## CORPORATION OF THE TOWNSHIP OF ESQUIMALT

### DESIGN REVIEW COMMITTEE AGENDA

WEDNESDAY, MAY 11, 2016

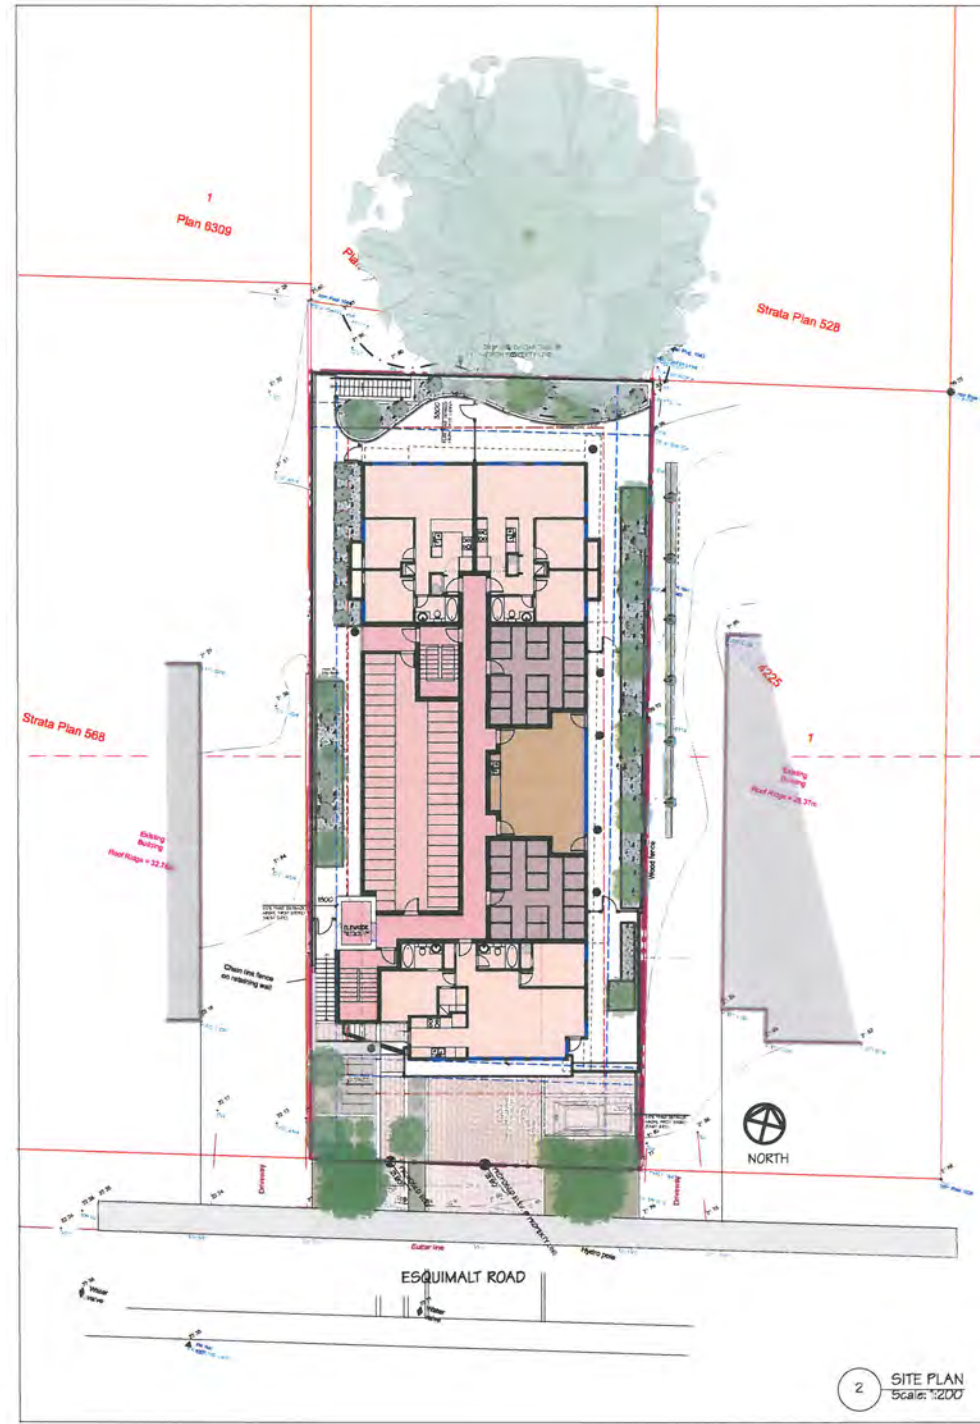
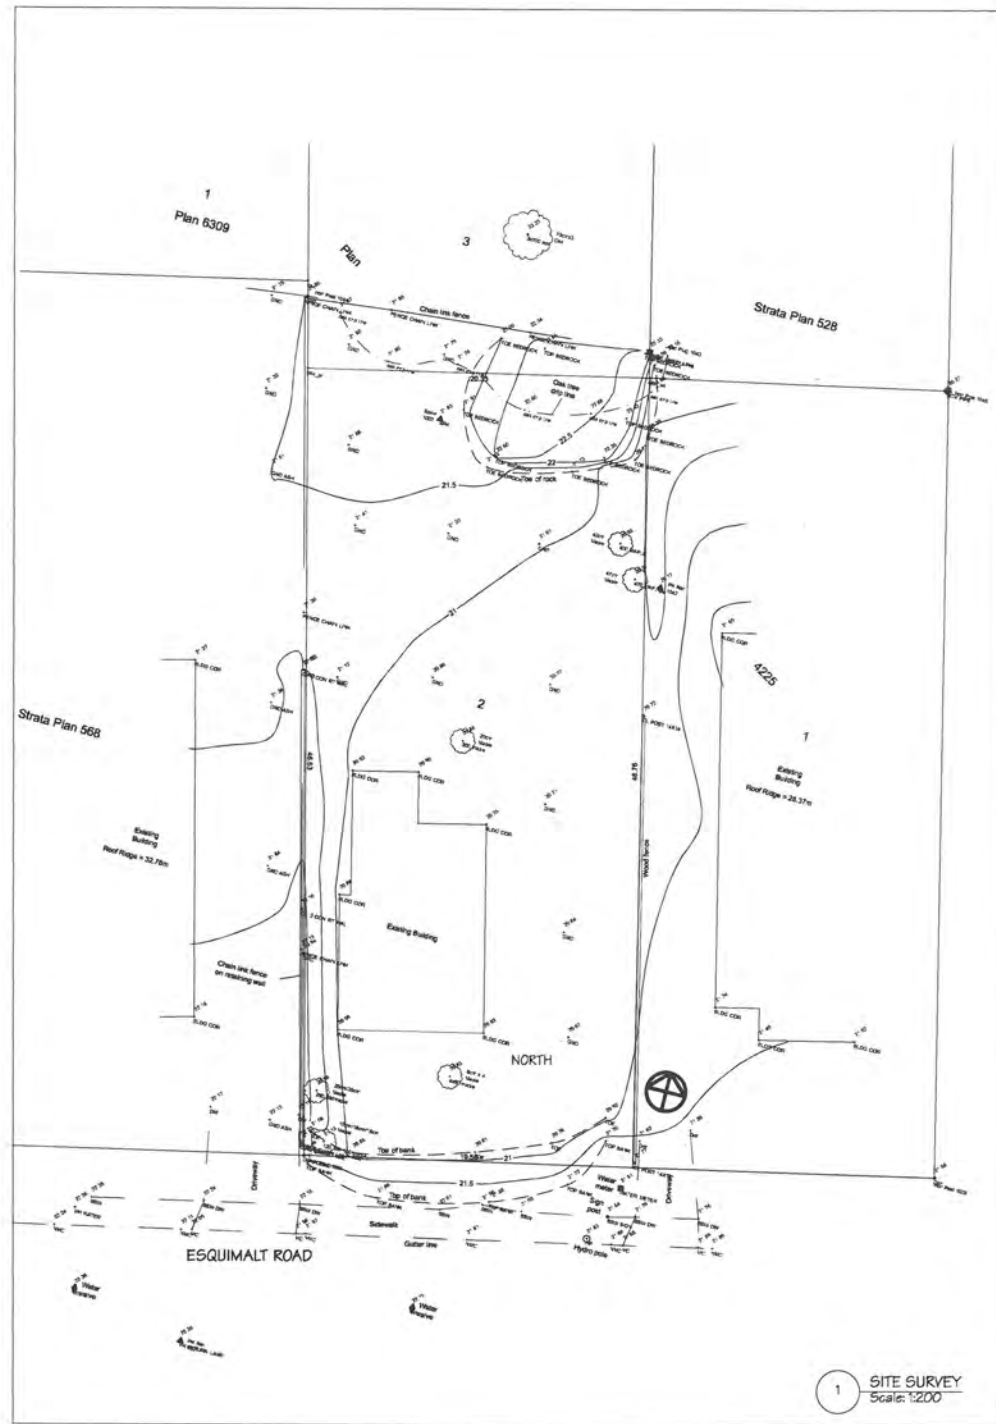
The main area of discussion seemed to relate to the parking structure and podium. The amendments to the plan are all focussed on these areas. Please note the following changes:

1. East and West Podium Planters have been recessed entirely into the parking structure and the above slab concrete retaining wall/railing has been replaced with a railing along each elevation. Replacing concrete with railings has reduced the "apparent" height of the parking structure by 25% from the east and west elevations and provides a better opportunity for plants to cascade over the side of the parking structure.

2. The expansion of the East Parking Grill has provided for a greater amount of planting area from within the parking structure that will allow more greening of the East Parking area. (The final amount of grill expansion will be dependent on structural engineering requirements)
3. The southeast grill area that separates the visitor surface parking from the below slab visitor parking has been increased in size to incorporate the entire available area that is not required for structural concrete posts
